ITEM 4.1 SUBMISSION TO DEPARTMENT OF PLANNING, HOUSING AND INFRASTRUCTURE - HOMEBUSH TRANSPORT ORIENTED DEVELOPMENT (TOD) REZONING SUBMISSION

This submission has been prepared in response to the exhibition of the Explanation of Intended Effect (EIE) for the Homebush Transport Oriented Development Precinct (TOD Precinct).

Perspective of proposed built form

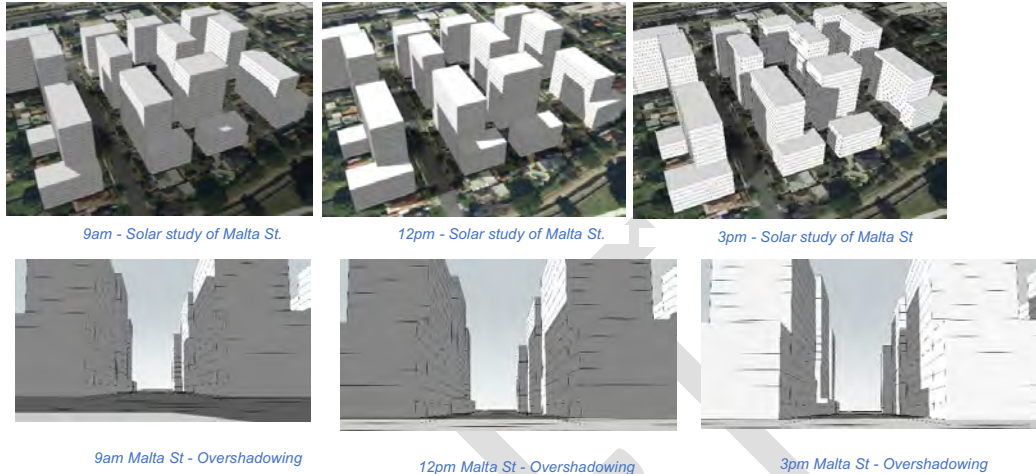
The masterplan prepared by COX Architecture will create an extremely dense precinct with monolithic street walls that overshadow streets and neighbouring buildings, creating an unpleasant environment for the future community. Some built form is located on flood-prone land, and there is no land set aside for schools.

The masterplan's height strategy concentrates height in the middle of the blocks to minimise the impact of tall buildings on George Street and to create a consistent lower height street wall along Powells Creek. However, this approach does not consider that the majority of streets in North Strathfield are oriented east-west, which will result in overshadowed and windy canyon-like local streets. Whilst the solar access diagrams show most apartments receiving an

These factors suggest that the proposed density is too high and it is recommended that the density be revised, based on:

- A detailed assessment of residential amenity and the amenity of streets,
- Adequate supply of non-residential uses and educational facilities, and
- Avoiding locating new buildings within floodways and high hazard flood areas.

Isolated sites

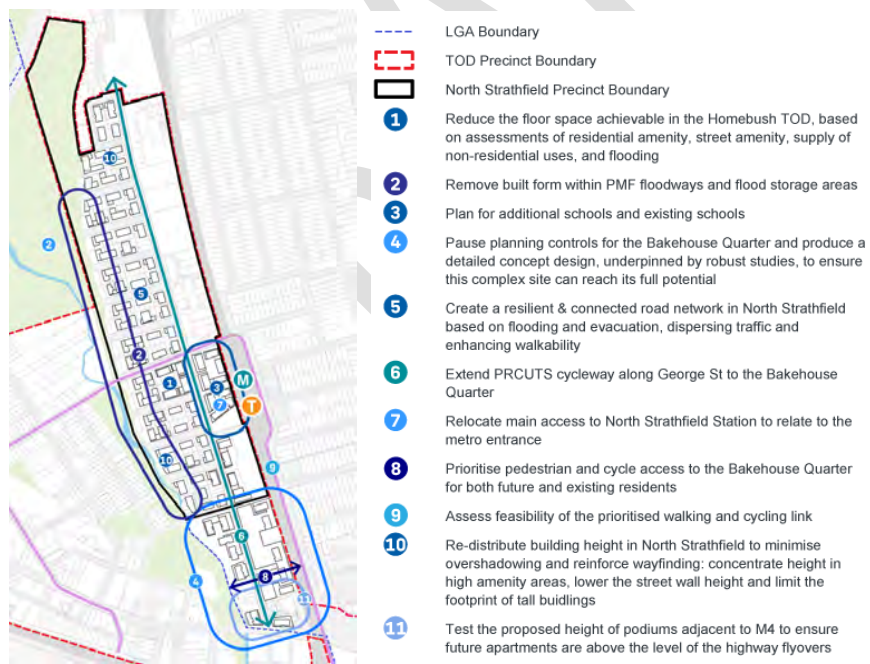
The requirement that sites be amalgamated as per the Key Sites Map does not extend across the entire Precinct. In addition to the delivery of roads and open space, Key Site provisions and minimum lot size requirements also require the amalgamation of land. The exclusion of a majority of sites within the Precinct from the Key Sites Map and an amalgamation requirement will result in ad-hoc development occurring as random land parcels are acquired and developed. This may result in isolated sites that lack the potential to be developed to a higher density in the future.

It is requested that the Key Sites Map be updated to include amalgamation requirements for all Lots, or the *Precinct Design Guide* be amended to include amalgamation requirements for sites not identified on the Key Sites Map.

Public Domain Plan

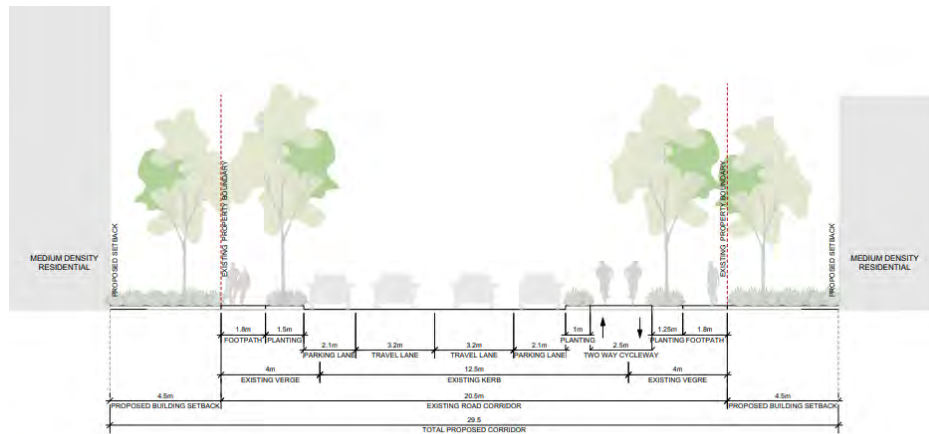
Other than outlining the general elements that should be included in a public domain plan, the *Precinct Design Guide* and the supporting *Public Domain Strategy* provide limited guidance for applicants and limited certainty for Council, who will inherit the land and works in public spaces.

As the planning authority responsible for the Homebush TOD, it is incumbent on DPHI to prepare a Public Domain Plan in consultation with Council. Such a Plan must include all open space within the Precinct boundary, publicly accessible through-site links and existing and proposed streets.

Alternative test site solutions: Mena St to Brussels St

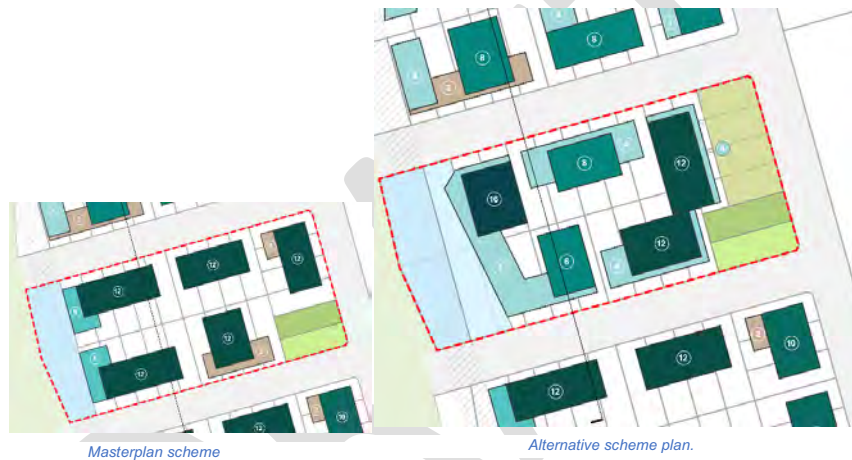
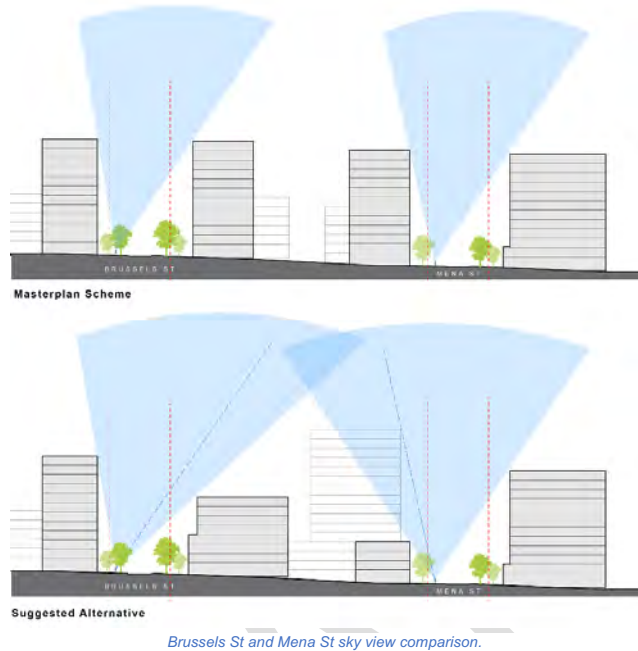
It also reduces the street wall to 4 storeys, allowing more light into the street and providing a wider view of the sky for pedestrians and residents of lower floors.
